URGENT - FIELD SAFETY NOTICE

**MAQUET *HLX 2004-5 DF, HLX 3004-5 DF and XTEN DF*
Field Action *MSA/2017/002/IU***

Field Correction Notice: **MSA/2017/002/IU**

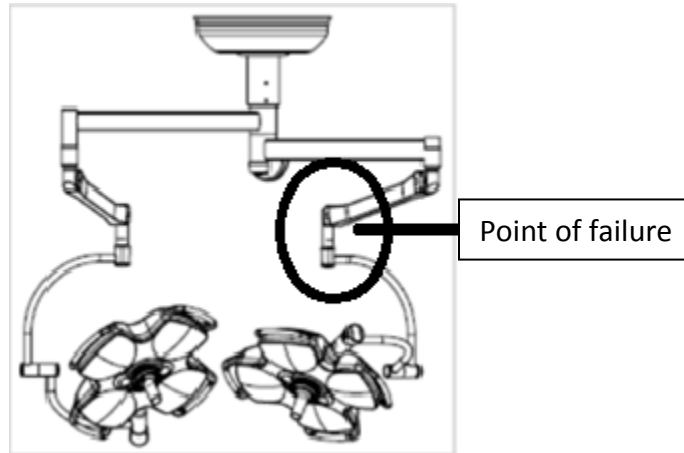
Product Issue: Breaking of AC2000 spring arms in use with HLX2004-5 DF, HLX 3004-5 DF and XTEN DF cupolas .

From our investigation it was concluded that there is a low failure rate that only can present itself on the devices of types and production identified in this letter. The issue relates to a crack in the metal of the spring arms that has the potential develop into a break. The devices are over ten years old and even so

This potential for malfunction is caused by fissures near the weld seam at the front pivot of the spring arm. The design of the spring arm was improved in 2006. The devices involved for your market are limited to those listed in the attached Consignee list.

Resolution: MAQUET proposes to replace the affected spring arms with new ones to make sure all devices present in the market are working effectively and safely.

This letter is to inform you of a corrective action that consists of replacing all potentially affected spring arms still in use with new ones. This action will be performed to prevent any possible hazard to persons and equipment.
